HILLCREST SUBDIVISION  
MASTER DEVELOPMENT  
PLAN #: 787A  
DATE: 08/22/03  
RESUBMITTED: 05/17/05

**REVISD  
MASTER DEVELOPMENT PLAN**

**HILLCREST SUBDIVISION**

Re: Hillcrest Subdivision (Amendment)

**SHEET  
1  
OF 1**

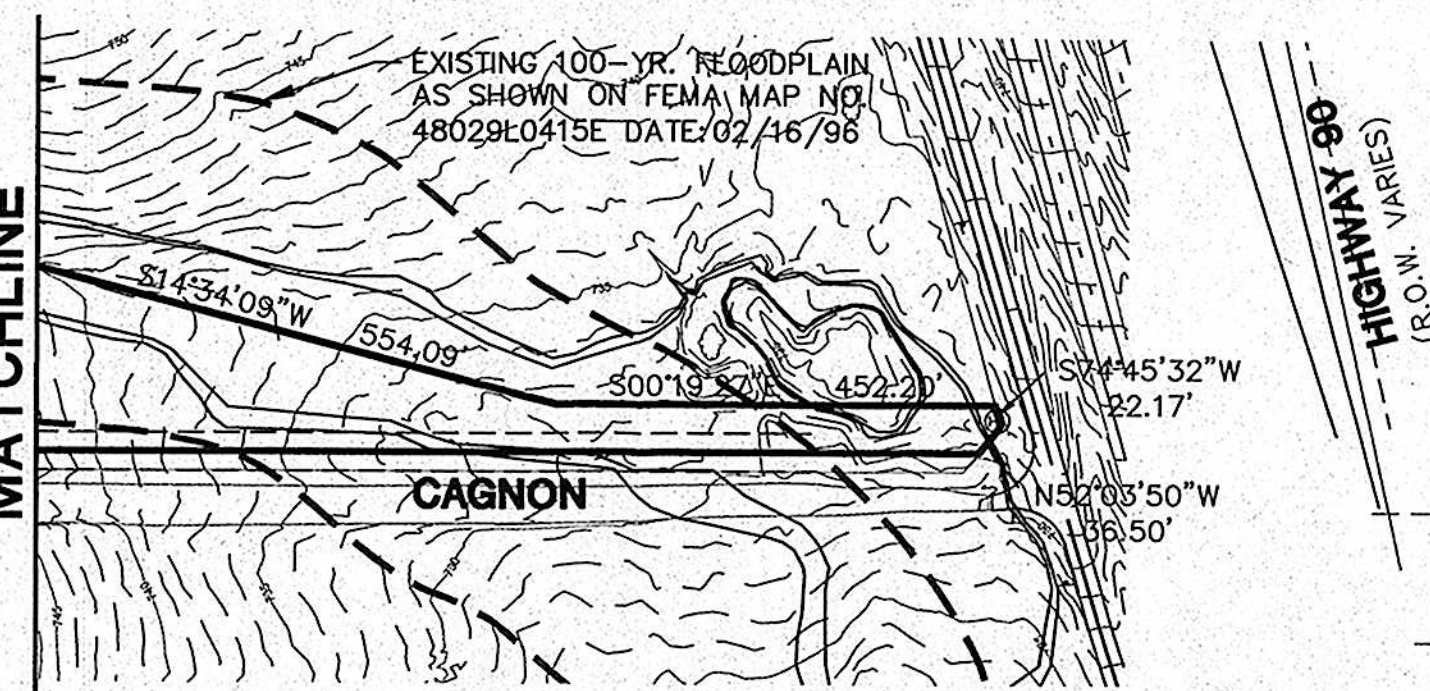
- The acceptance of this Master Development Plan # 787A is confined to the boundary limits of the site. Any projection(s) of future roadways outside the boundaries does not infer any set alignment of future roadways. All major arterials and streets shall follow all regulations.

- In consideration of public safety and convenience, excessive grades by reason of topography should be avoided in street layouts and arrangements.
- Storm Water Engineering has reviewed this MDP and cites the following:

- Streets and Drainage have reviewed this MDP with the following comments:
  - Whether detention is required or not will be determined by Public Works Storm Water Engineering during the platting process. If detention is required, then the construction plans and calculations for the pond will be reviewed by Development Services at the technical reviewing stage and will have to follow the Unified Development Code.

- It should also be understood that this is a conceptual plan that all UDC requirements will be implemented for all plats, within the limits of this MDP, at the technical reviewing stage. This includes such items as intersection sight distances, street design and pavement requirements, traffic calming, cul-de-sac requirements, and right-of-way requirements.

- The Developer shall provide 35 feet of ROW from the centerline of Cagnon Road (Collector) and it is recommended that the developer construct 22 – feet of pavement adjacent to the proposed project limits as shown on the MDP.
- Construction of an internal collector street system. Collector streets with 70-feet of ROW and 44-feet of pavement shall have no houses fronting.
- All Roadways shall conform to Table 506-1: Functional Classification System Description.

- All roadways accessing Loop 1604 shall have right turn deceleration lanes as per TxDOT standards.

- Parks and Recreation recommends approval with the following conditions.
  - Applicant applies for and receives a variance of the one-acre minimum size requirement for Park Area I in Unit 1.

- The following improvements are to be constructed within the Park Area 1:
    1. Recreation/Community Center with a minimum of 1,000 square feet.
    2. Swimming Pool with minimum surface area of 2,500 square feet.

- The development of a Park Area 2, a minimum size of 2.9 acres, in Unit 5B with the following improvements:
  1. An Open Play Area. This area is to be a minimum of 20,000 square feet of unobstructed space with a maximum slope of five (5) percent, and a minimum width of 100 feet. Common Bermuda or similar turf grass to be established in this area.
